Technical Note

201-27 (202, 203, 204)  
205-17, 206-14  
301-34, 303-15, 304-5  
401-21, Falcon Nr.2

Subject: Elevator actuating bracket

Effectivity: All serial numbers:  
Models H 301 Libelle, H 201 Standard Libelle, H 202, H 203, H 204, Club Libelle 205,  
Hornet, Mosquito, Glasflügel 304, Falcon, Kestrel

201-33-4

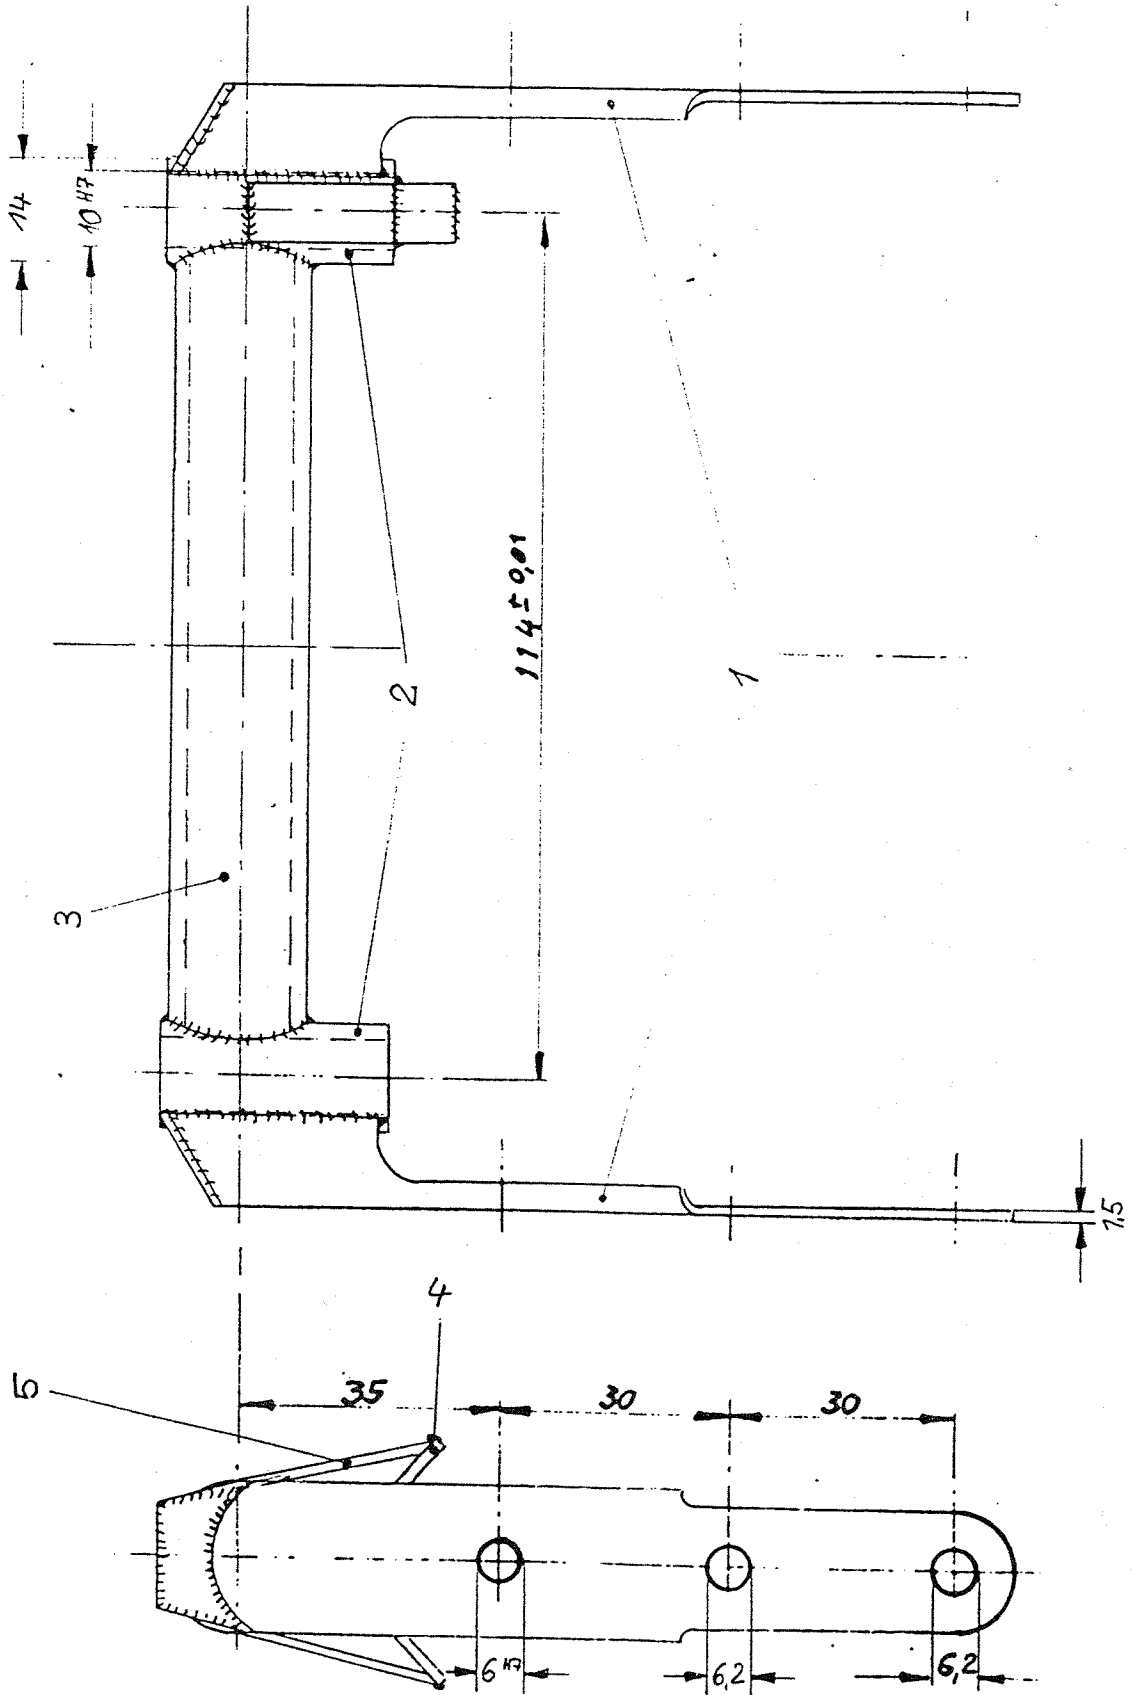
Reason: Use of a bracket as per drawing no. 201-33-4 instead of former bracket types permissible.

Actions: In case of elevator actuating exchange use following procedure:  
Unscrew the 6 screws on the elevator actuating bracket. Pay attention to the type and number  
of washers at each bolt. Mark position precisely!  
Install new actuating bracket including the washers on the same position.  
Tighten screws carefully and check free motion of the elevator.

Material: Elevator actuating bracket according to drawing no. 201-33-4 is available from
